Dale Hey Bungalow
 Preston Road
 Ribchester
 PR3 3XL *PROPOSED NEW ACCESS AND DRIVEWAY TO GARAGE*
 DDG REF 2317 CB/RF.

please ask for: Adam Birkett
direct line: 01200 414571
e-mail: Adam.birkett@ribblevalley.gov.uk
my ref: 3/2017/0813
your ref:
date: 11 October 2017

FORMATION OF A NEW ACCESS AND DRIVEWAY TO DALE HEY BUNGALOW, PRESTON ROAD, RIBCHESTER

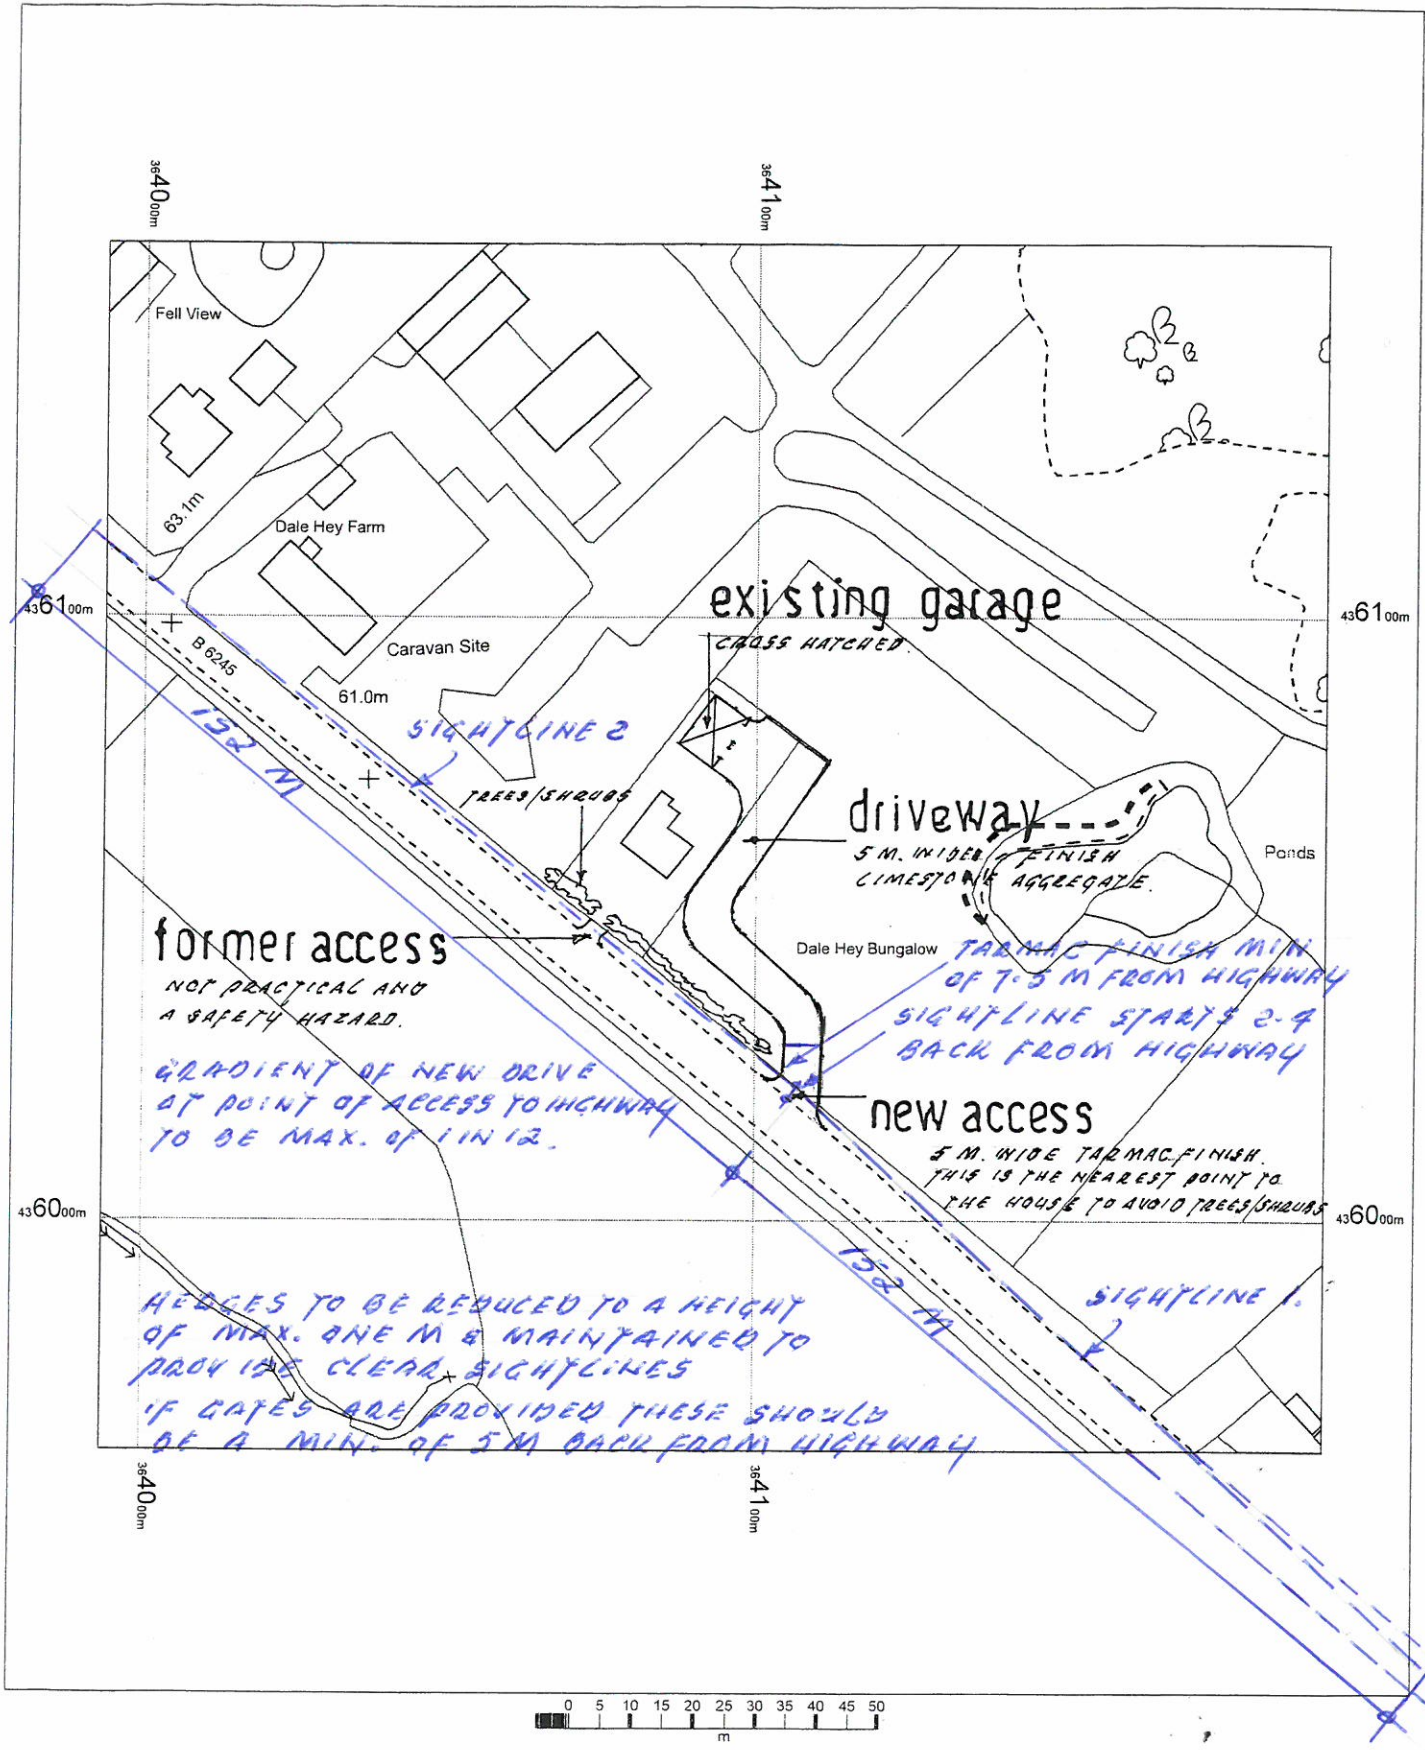
I have received representations from the County Surveyor (Highways) who has stated that an objection is raised against the application until plans are submitted that include the following features:

- Alterations be undertaken to achieve the necessary sightlines at the point of access. Sightlines both sides of the junction would need to be 200 metres if possible and at least 152 metres as an absolute minimum. These sightlines would need to be possible from a point that is 2.4m back from the edge of the highway. Such work may require some of the hedges to be reduced to and maintained at a height not exceeding 1 metre.

- A plan to indicate that there will be at least 7.5 metres of bound surface between the edge of the highway and the limestone aggregate road.
- Plans to indicate that any gates will be placed 5 metres back from the edge of the highway to ensure that they can pull clear of the highway. If vehicles of longer than 5 metres are expected to use this access point when it is completed then the gates should be set further back.

- Plans to indicate a cross section of the access point indicating the gradient of the new drive at the point of access to the highway.

REVISION 'A' NOTES ADDED FOR HIGHWAYS DEPT.

*NOTES ADDED TO
PLAN 16/10/17*
